PS ref: 8433

LOT 100 (109) PALMERSTON STREET, PERTH 6000
OBJECTION TO PROPOSED DEVELOPMENT OF FOUR GROUPED DWELLINGS
UNACCEPTABLE LEVEL OF OVERSHADOWING TO ADJOINING PROPERTY

Figure 1 – Overshadowing analysis with the strata lot boundaries included

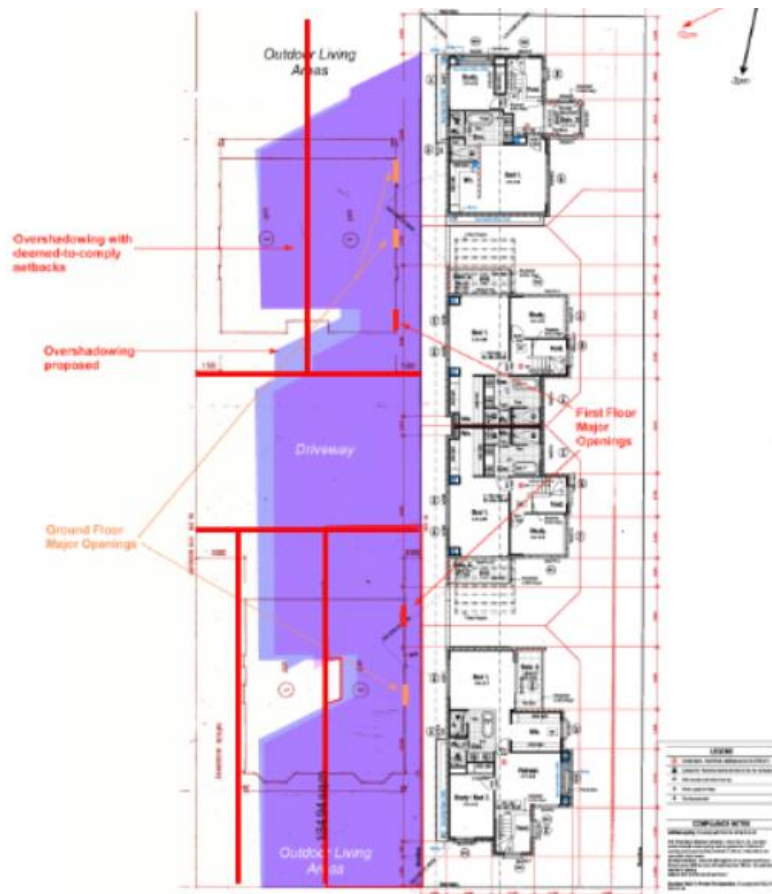
In fact, the extent of the impact is masked somewhat by reference to the overshadowing of the overall site only. A more individualised assessment of the impact upon the individual neighbouring dwellings within the development (excluding driveway areas) demonstrates the full extent of overshadowing:

- The residents of **Unit 1** will experience overshadowing of **74%**, meaning that the majority of their outdoor living area will be cast in shade by this development.
- The residents of **Unit 2** will experience overshadowing of **95%** including the complete overshadowing of their outdoor living area and the obstruction to daylighting of five of their windows.
- The residents of **Unit 4** will experience overshadowing of **73%**, with half of their outdoor living area cast in shade and daylighting to five of their windows completely obstructed.

This can be seen more clearly by showing the internal lot boundaries on Figure 1 below.

It clear the only compromise here is by the neighbouring residents and owners of No. 107, the majority of whom will have to live with their outdoor living areas being in shadow for much of the day, 4 months of the year. The proposed overshadowing will also result in the blocking of direct solar access to a number of the major openings to habitable rooms.
